Preliminary Change Request for the Chromatic Sextupoles and Trim Quadrupole Elements of the SNS Accumulator Ring

BNL/SNS TECHNICAL NOTE

NO. 075

May 30, 2000

Figure 3: Lattice functions of the SNS accumulator ring for the nominal tunes (6.3,5.8) using two families of sextupoles. The beta and dispersion functions are strongly perturbed for off-momentum cases.

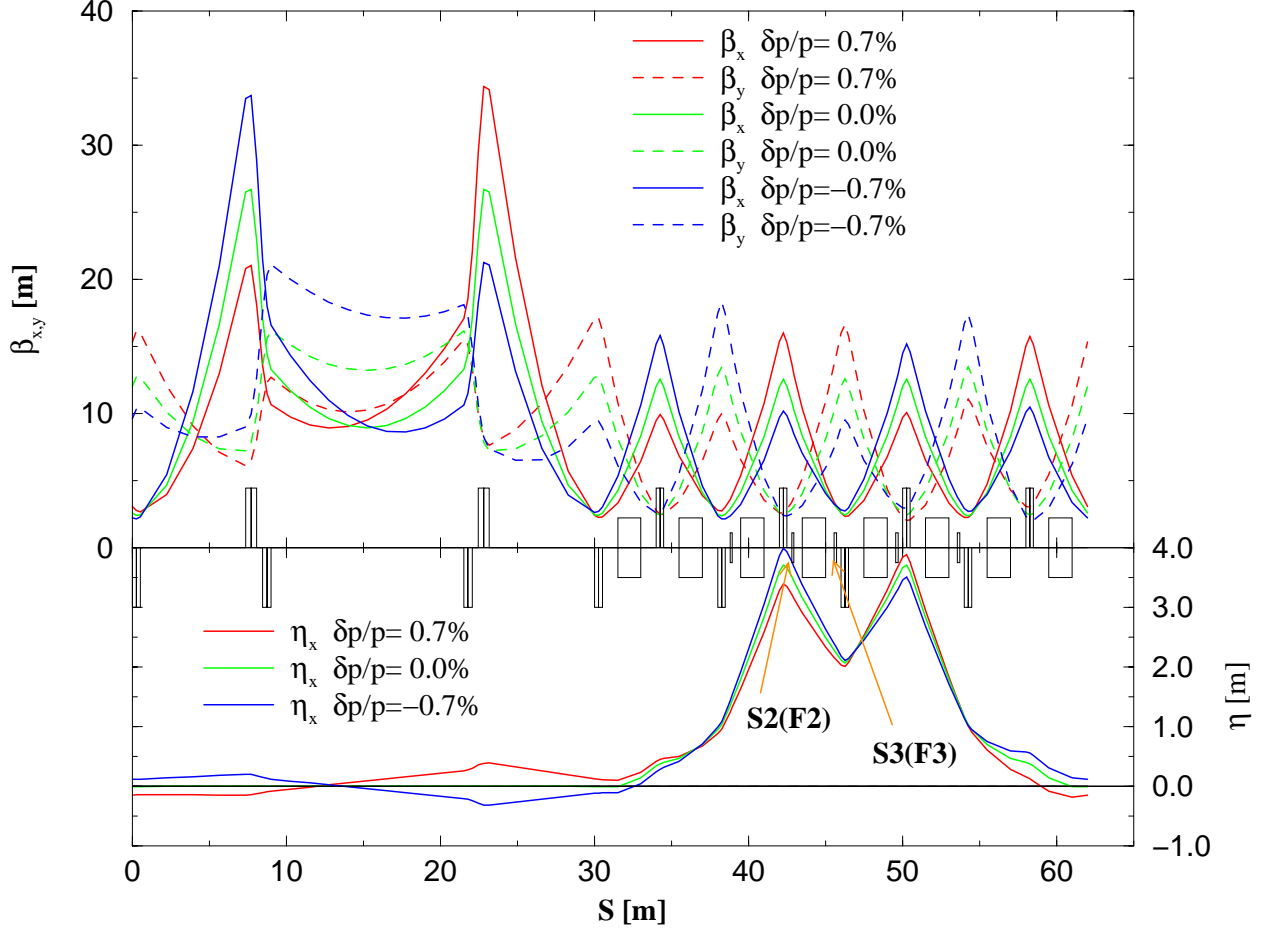
Two families of sextupoles, placed at high-beta and high-dispersion regions, can control the linear chromaticity of the ring. The sextupoles however may strongly affect the first and second order of the beta and dispersion functions dependence on the momentum spread, introducing strong “beta/dispersion waves” and, thereby, reducing the dynamic aperture. In addition, this beta/dispersion variation will increase the first and higher order terms of the chromaticity. This is clearly shown in figure 3: with a two-family scheme, the optical distortion in β -function is as large as 30% for off-momentum orbits.

In order to minimize the dependence of the beta, the dispersion functions and the chromaticity on $\delta p/p$, additional families of sextupoles are required. In the proposed chromaticity correction scheme, three of the sextupoles are powered independently and two of them in

Figure 4: Lattice functions of the SNS accumulator ring for the nominal tunes (6.3,5.8) using 4 families of sextupoles. The beta and dispersion wave has been minimized by the introduction of the 2 supplementary sextupole families.

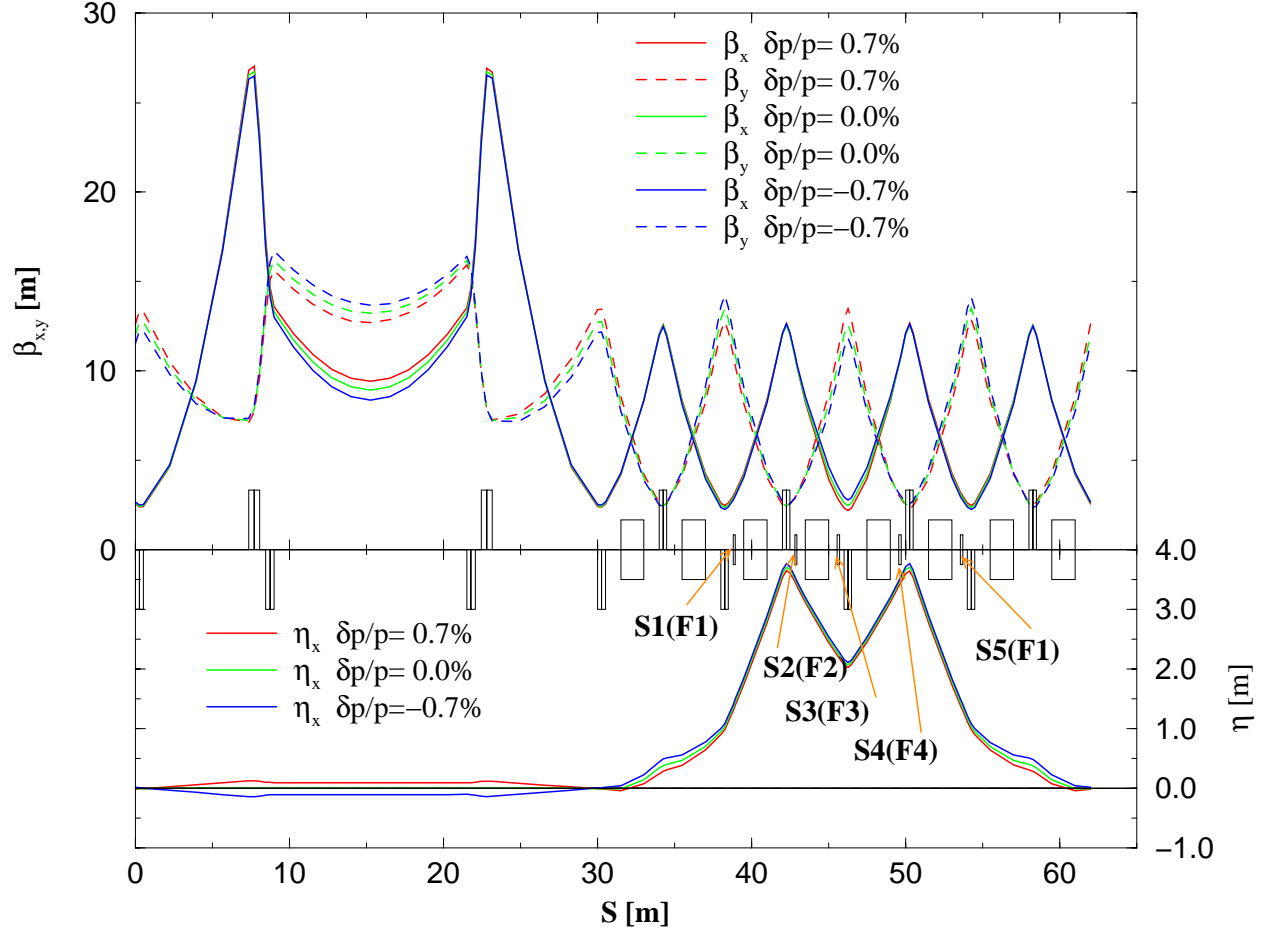
series, forming a total of four families. With a four-family scheme, the off-momentum optics is greatly improved, and the β -wave is minimal (Fig. 4).

Figure 5: Sextupole strengths for the four families of chromatic sextupoles versus the chromaticity. The maximum values are within the strength requirements (Table 2.1).

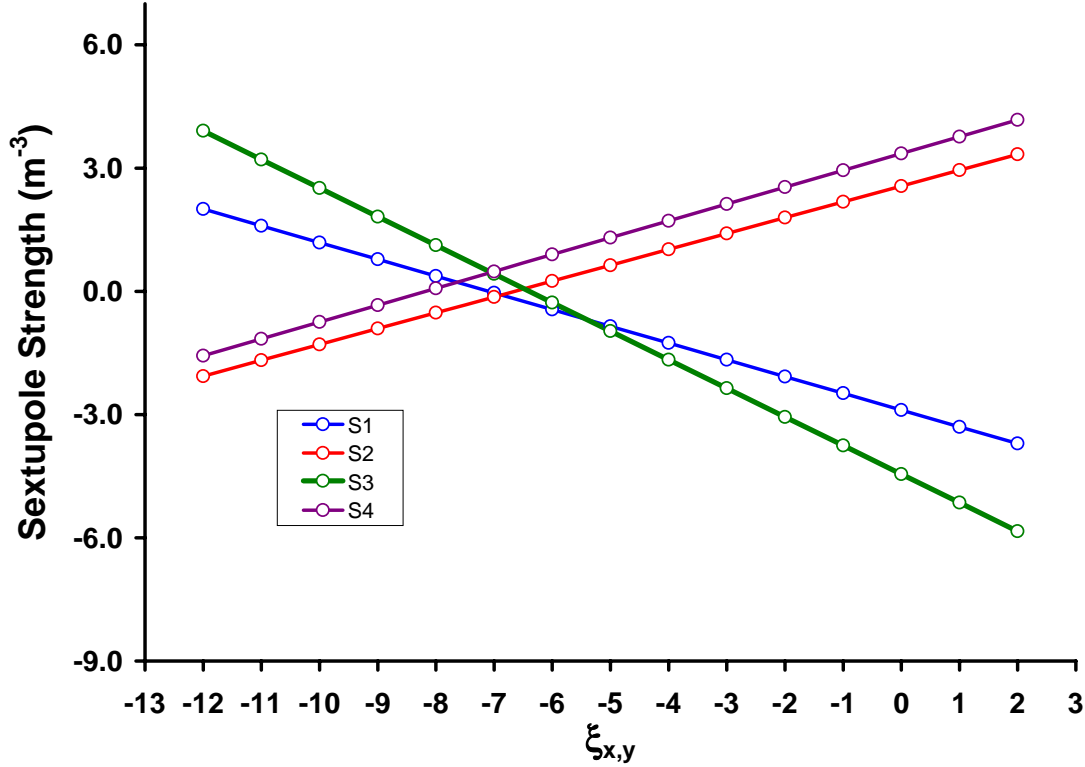
By using the HARMON module of the MAD program [4], we have computed the required strength of the four families of sextupoles in order to adjust the horizontal and vertical chromaticity $\xi_{x,y}$ to a wide value range and at the same time to minimize the optics functions' perturbation (Fig. 5). We observe that the sextupole strengths for the most extreme cases are less than 6m^{-3} . Thus, the strength requirements of 8.3m^{-3} , given in Table 2.1, are sufficient to handle the chromaticity/optics control, leaving a comfortable 20% margin.

Figure 6: Anharmonicities versus the chromaticity. The maximum values are within 5% of the ones produced by the quadrupole fringe-fields.

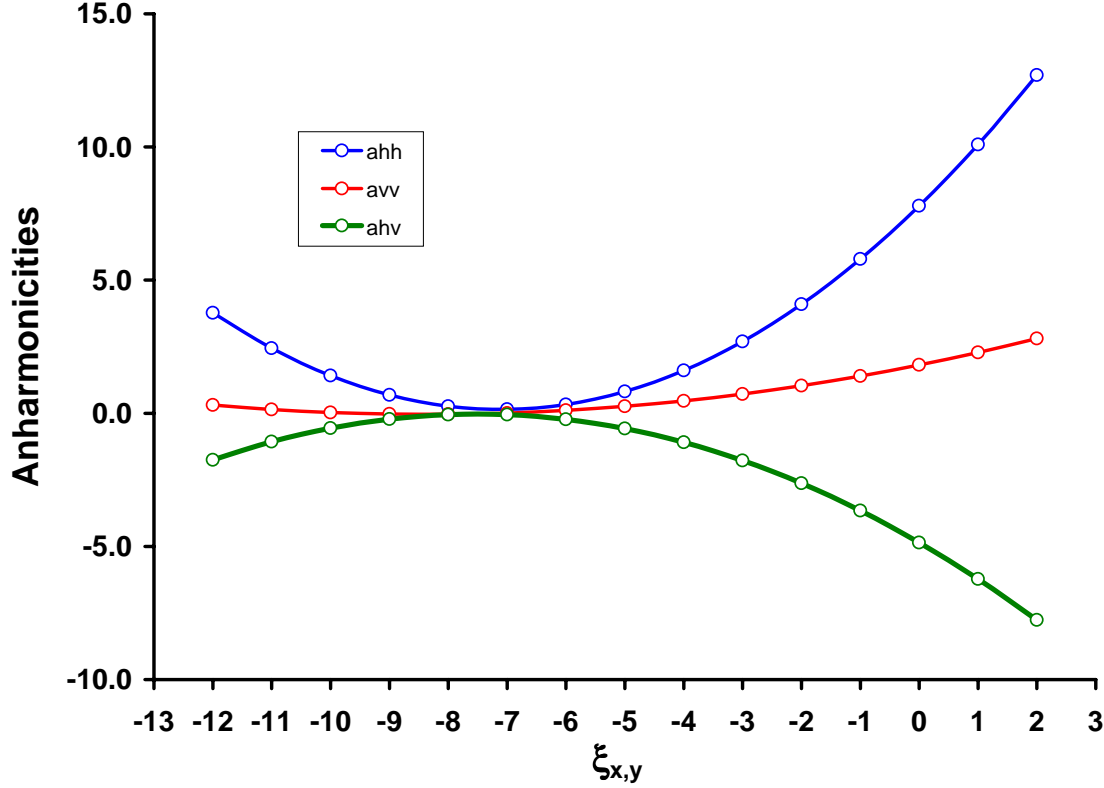
three quantities have been computed for all range of chromaticity values and plotted Fig. 6. The maximum anharmonicity values are found to be a factor of five smaller than the ones introduced by the quadrupole fringe-fields [5], indicating that the introduction of chromatic sextupoles will not have an important non-linear impact on the SNS ring. This residual octupole-like tune-shift can be corrected by dedicated octupole correctors [5]. Additional tracking studies are in progress in order to further justify the small impact of the chromatic sextupoles in the non-linear dynamics of the SNS ring.
